Interactive comment on “GIS analysis of effects of future Baltic Sea level rise on the island of Gotland, Sweden” by Karin Ebert et al.

nhess-2016-55

Response to Anonymous Referee #2

Fig. 1.

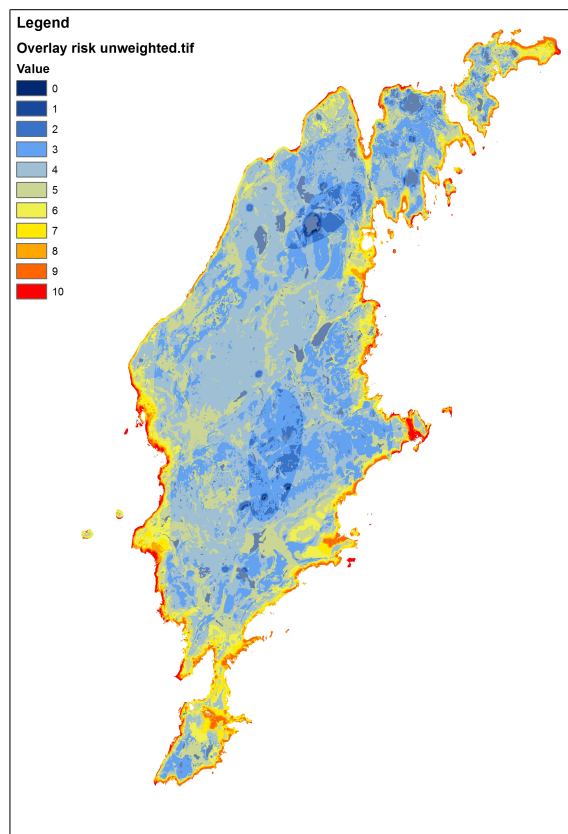
Rev: The novel of the paper is the use of detailed LIDAR data for the GIS evaluation. My concern is regarding the use of information for the RV method. It is not structured, which it should be according to the principles behind the RV-method, instead uses factors and weights without critical discussion, handling those as if they represent a truth value of salinization risk (see more detailed discussion below). I suggest a major revision of this part and/or present data that support the use and choice of the factors.

Rev: The method used refers to the RV-method and the authors explain that the parameters and the weighting used are similar to what previously been developed for Sweden and Gotland. However, the authors have unfortunately not understood the dynamics of the RV-method. The factor values should be ranked from negative to positive values since it is the extreme conditions that will have a most significant influence on the results. The RV-method also comprises an uncertainty evaluation in the same manner and factors and weighting should be based on a multistatistical evaluation of existing

Rev: The papers present five factors included in the risk analysis for saltwater intrusion with reference to a non-published undergraduate report. The choice of factors is therefore unclear.

Response: We considerably revised the manuscript in the light of these overall comments, which we found to be important. In particular, we now critically discuss the choice of factors, and we additionally test the robustness of our results, by performing and evaluating a new set of analyses based on different (yet still realistic) assumptions regarding risk values. See further our detailed response below.

Figure captions for the two figures below: Figure 1. The overlay analysis of saltwater intrusion risk with unweighted values (figure 6 in our paper shows the same analysis with weighted values for sea level rise). The results of the weighted and unweighted overlay are relatively similar, indicating that the result is robust. Despite the similarities, we argue from a methodological viewpoint to keep our weighted analysis in the main text of the manuscript, since higher values for low elevation above sea level and closeness to the coast reflect known and well-investigated effects sea level rise.

Fig. 2.

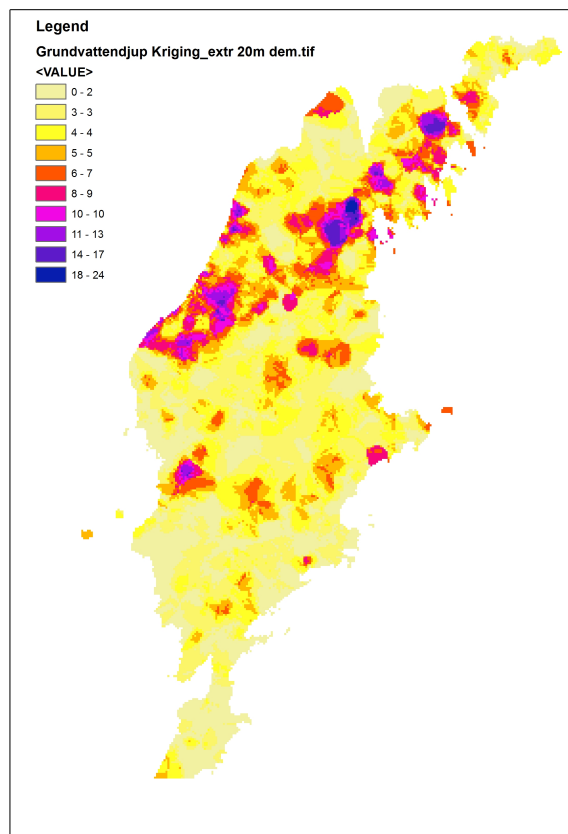
Rev: The figures are generally good and informative. However, there is no information given which interpolation method is used for the spatial analyses, e.g. figures 3B, 4, 5 and 6. There is a significant difference for different interpolation methods (e.g. kriging, IDW, linear interpolation. . .)

In figure 4A, we chose IDW to interpolate the estimated depth to groundwater. To

show the overall pattern of many point values, the different interpolation methods show barely any differences. Below figure 2 in this response to illustrate that the result for Kriging are strongly similar to those of IDW.

Figure 2. Estimated depth to groundwater interpolated using the KRIGING method.
